FIRST FLOOR FRAMING PLAN

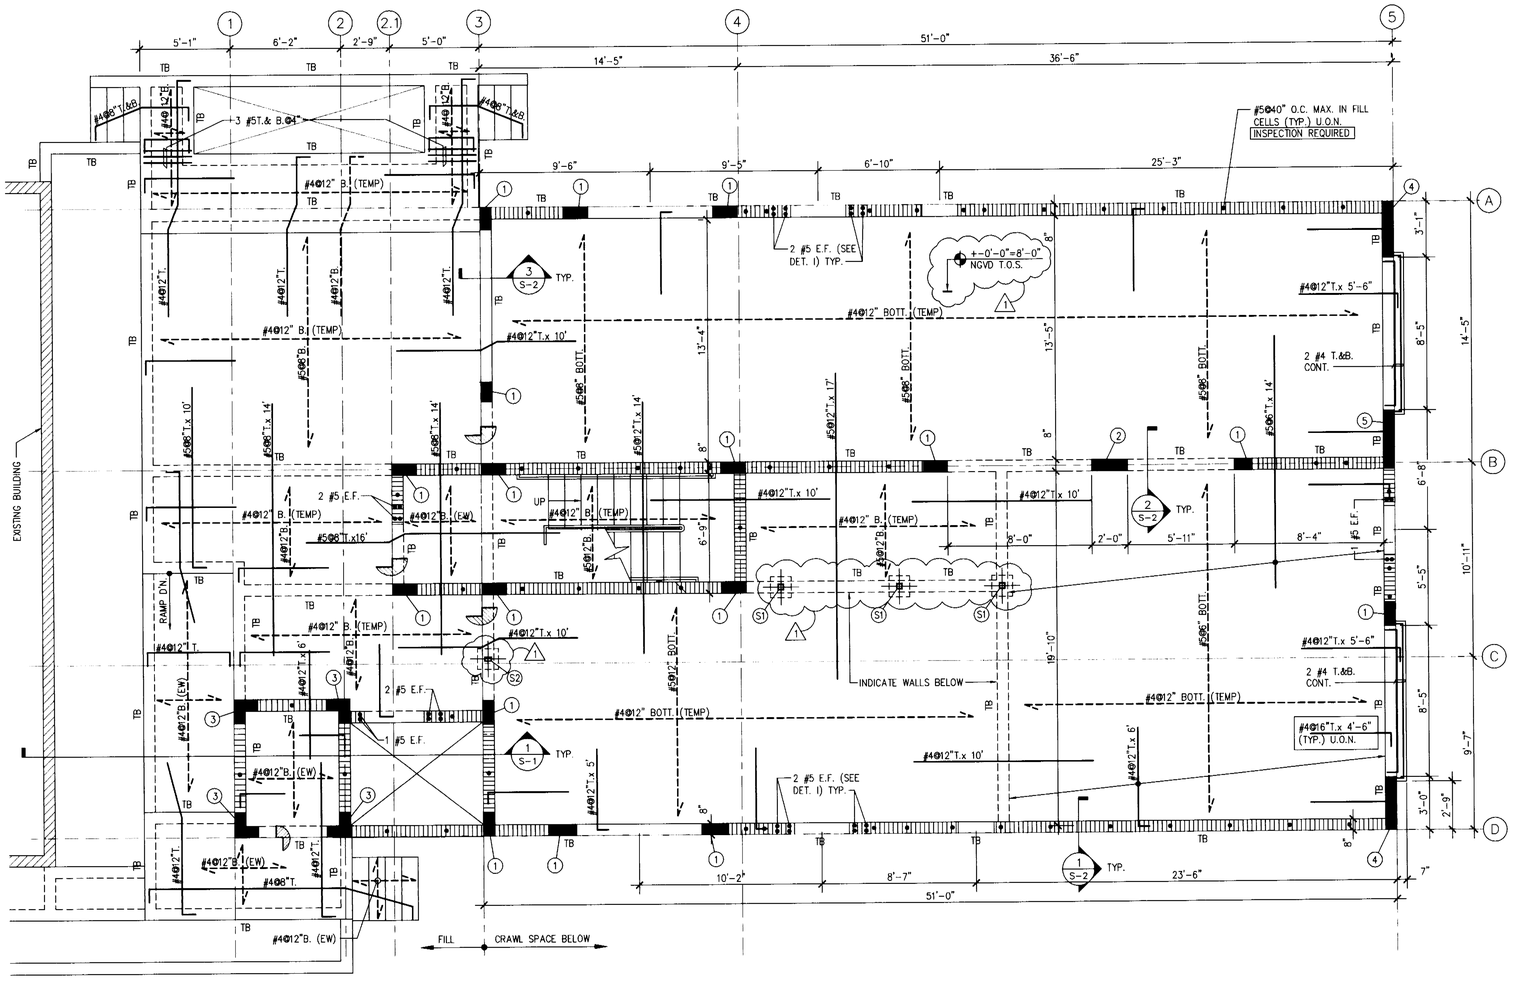
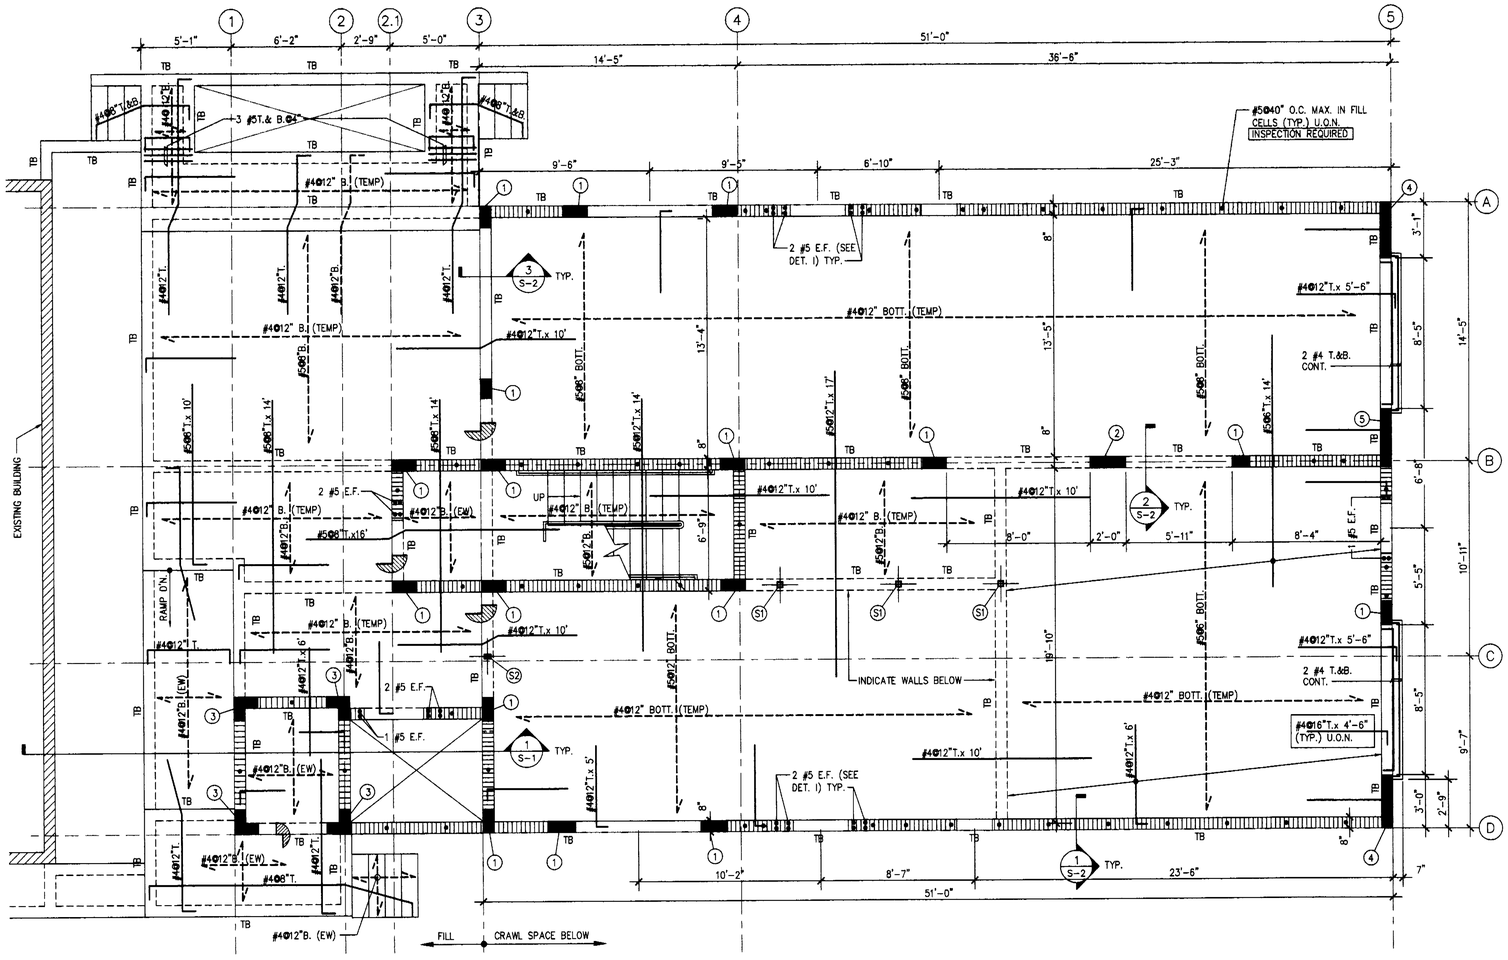
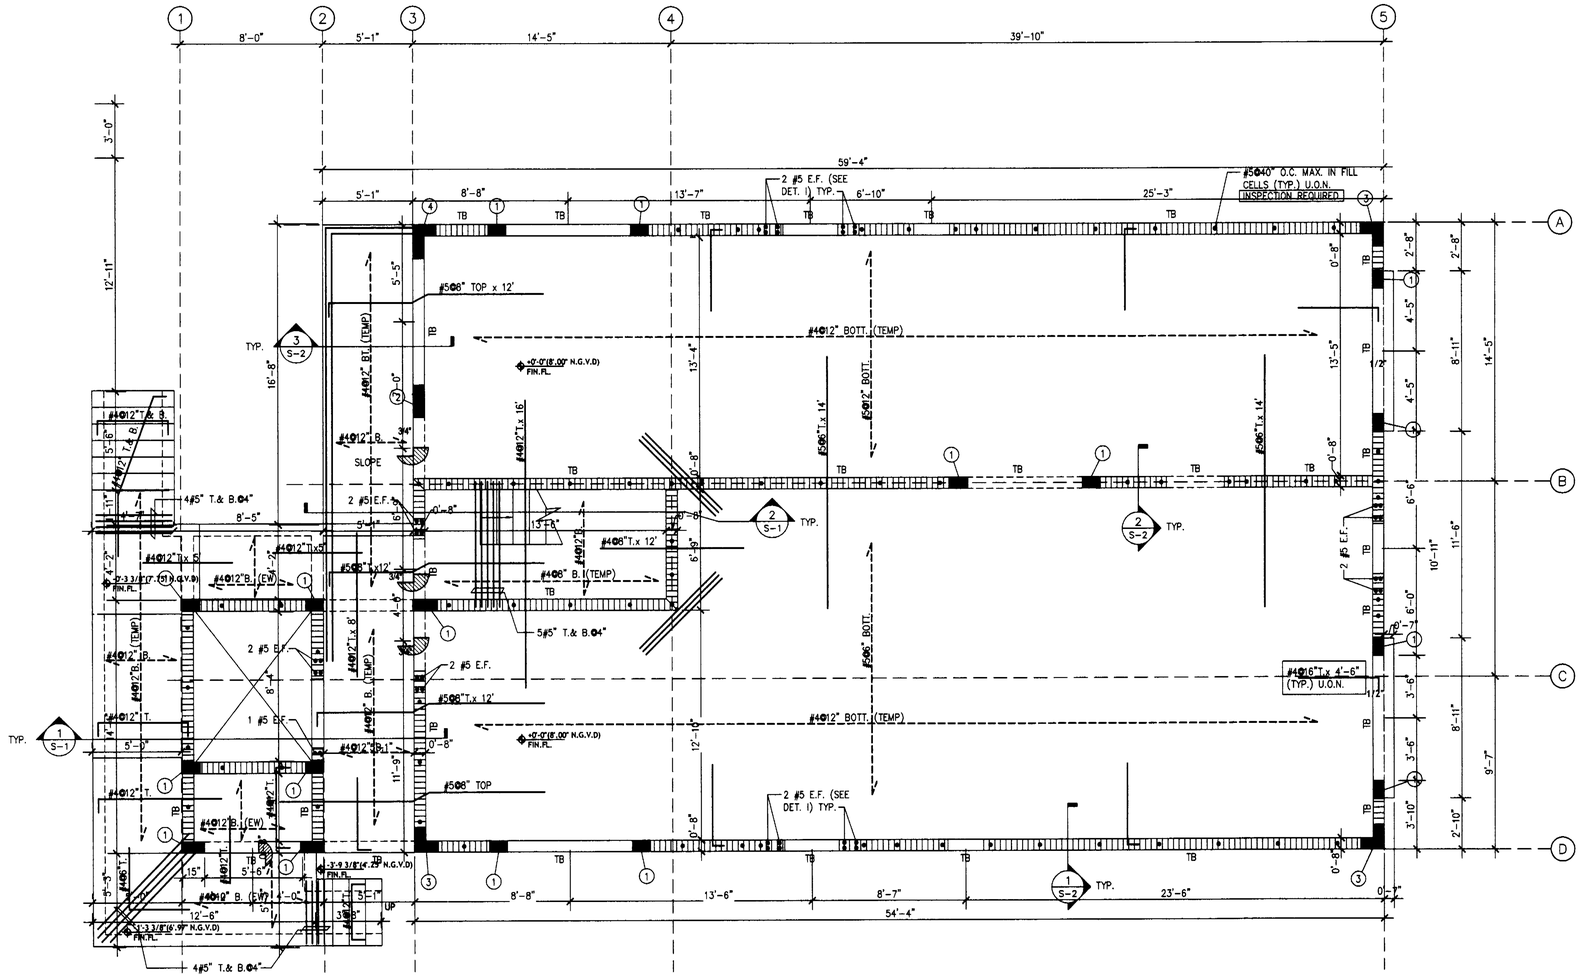
7.1 Comment was not addressed. There is still conflict between sections and ground floor framing plan. (CORRECTED: COMPLETION NOTES VOID).

1ST FLOOR PLUMBING PLAN

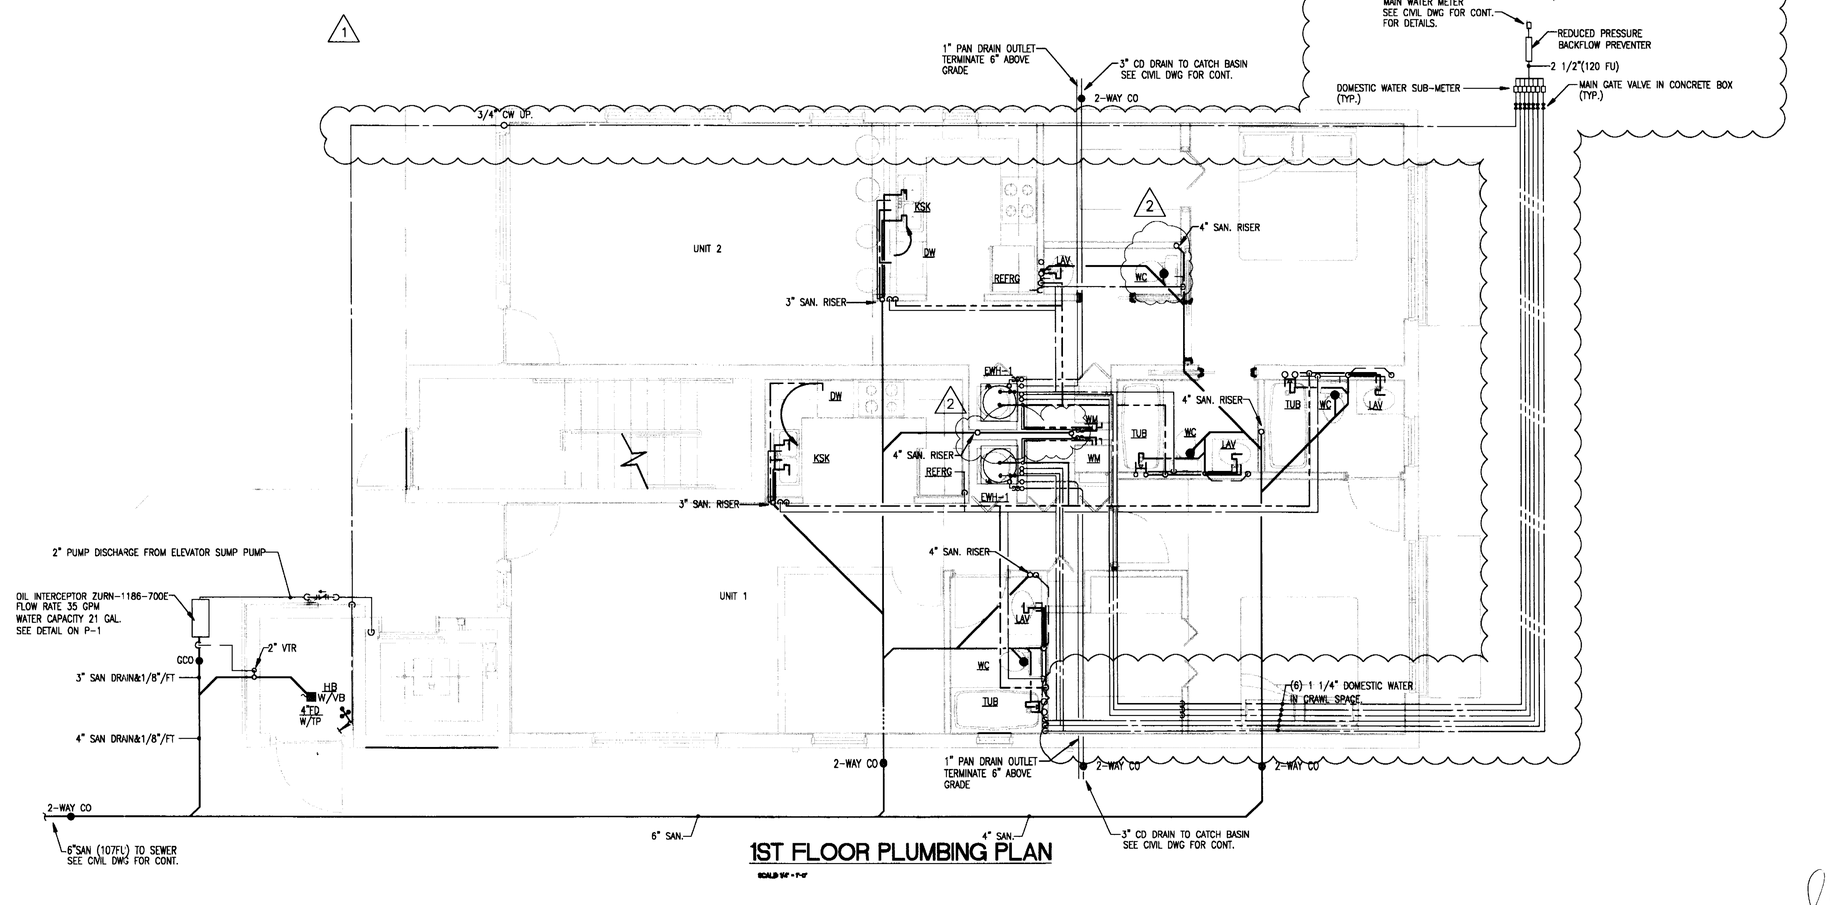
NEED TO BE RELOCATED TO REAR OF PROPERTY

IRRIGATION PLAN

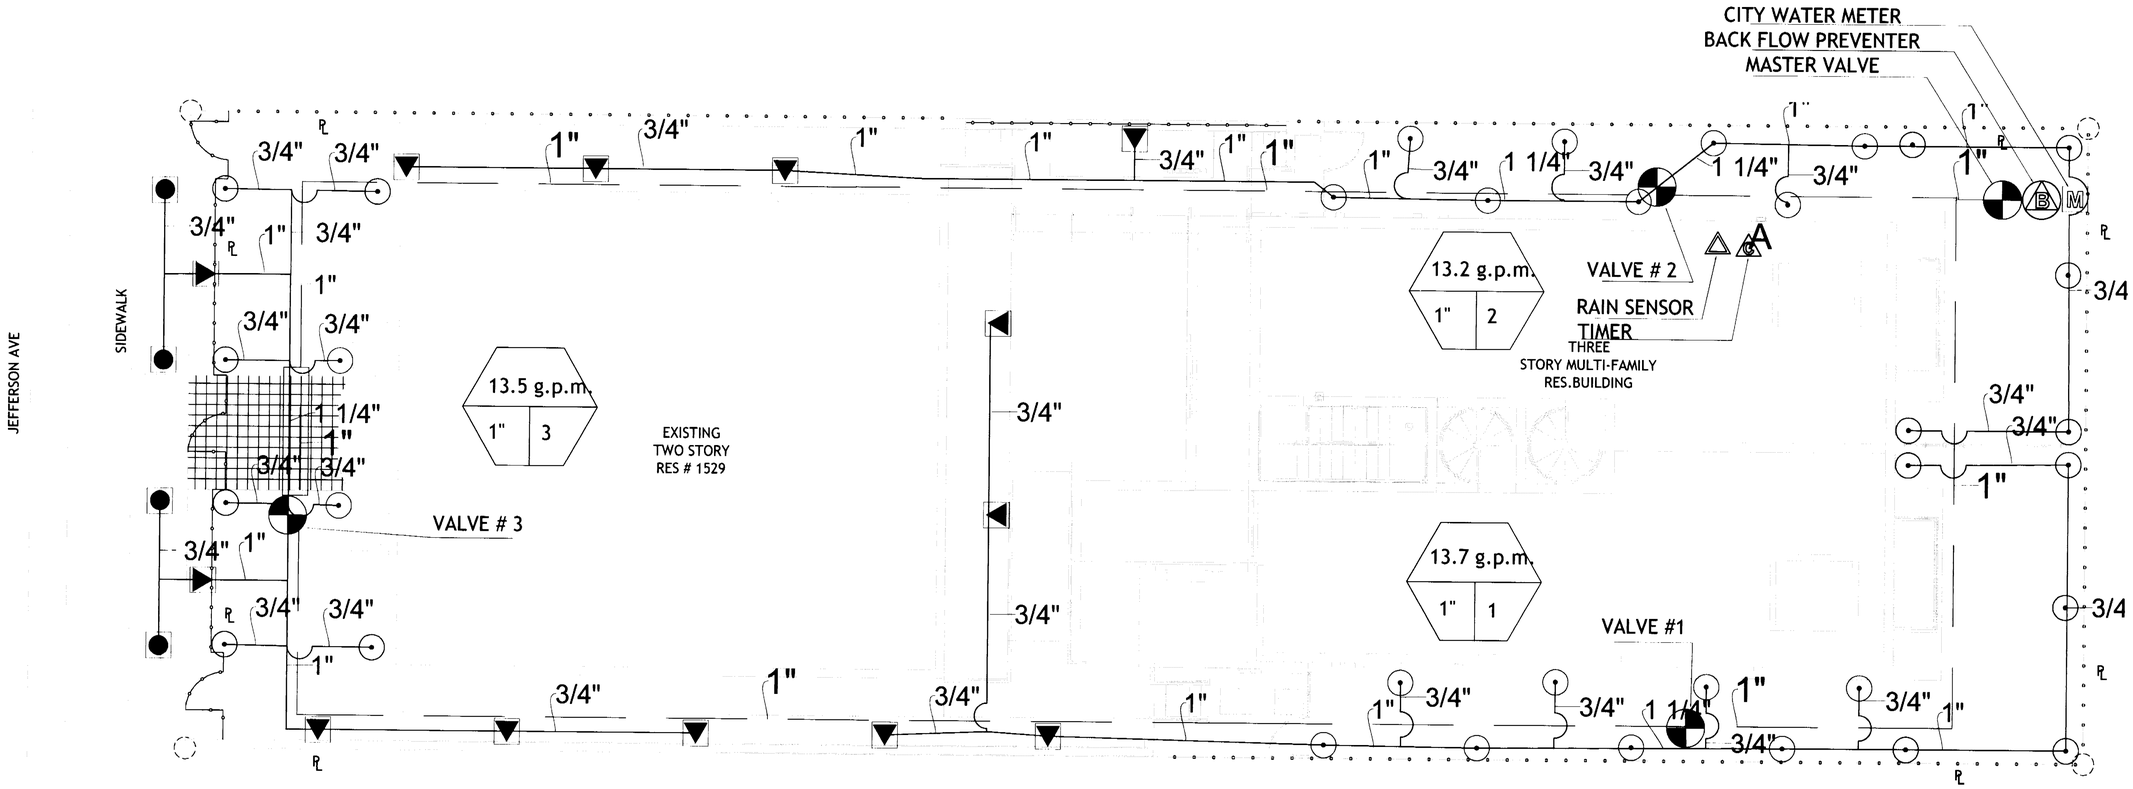
-Provide irrigation sheets.
Please see sheets IR1 and IR2, irrigation sheets.
